Access Compliance Report

Public Rights-of-Way

(Curb Ramps)

Intersection ID: 53624	Main Street: PROSPERITY RIDGE RD	Cross Street: RIDGE RD	Location: NW
ADA ID: 5CDBF5A09B07	Ramp Type: Directional1	Initial Pass/Fail: Fail	Overall Compliance: No
Severity Score: 13.75			
Codes/Mitigation Info/Possible Solution		Field Measurements/Component Compliance

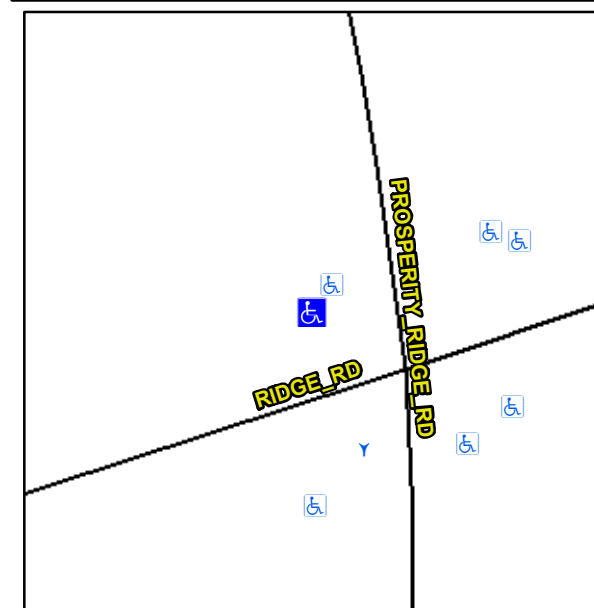
R304.2.2

Compliance	Description	Data	Compliance	Description	Data
N/A	Ramp Length (in)	109.0	N/A	Grade Break?	N/A
Yes	Ramp Width (in)	60.0	N/A	Grade Break Slope (%)	0.0
No	Ramp Slope (%)	9.4	N/A	Grade Break XSlope (%)	0.0
Yes	Ramp XSlope (%)	2.7			
N/A	Flare Type LT	N/A	N/A	Flare Type RT	N/A
N/A	Flare Slope LT (%)	N/A	N/A	Flare Slope RT (%)	0.0
N/A	Flare Traversable LT?	N/A	N/A	Flare Traversable RT?	N/A
N/A	Landing Length (in)	0.0	N/A	DWS Provided?	N/A
N/A	Landing Width (in)	0.0	N/A	DWS Contrast?	N/A
N/A	Landing Slope (%)	0.0	N/A	DWS Length (in)	N/A
N/A	Landing X Slope (%)	0.0	N/A	DWS Full Width?	N/A
N/A	Landing Curb? (Y/N)	N/A	N/A	DWS Offset LT (in)	N/A
N/A	Shared Landing?	N/A	N/A	DWS Offset RT (in)	N/A
N/A	Gutter Ponding?	0.0	N/A	Gutter Slope (%)	N/A
N/A	Gutter Lip Ht (in)	0.0	N/A	Gutter X Slope (%)	N/A
N/A	Painted X Walk1?	Yes		Road Slope (%)	3.6
	X Walk 1 Direction	To S		Road X Slope (%)	3.0
	X Walk 1 Width (in)	112.5		Clear Space?	N/A

Remove & Replace Entire Ramp.
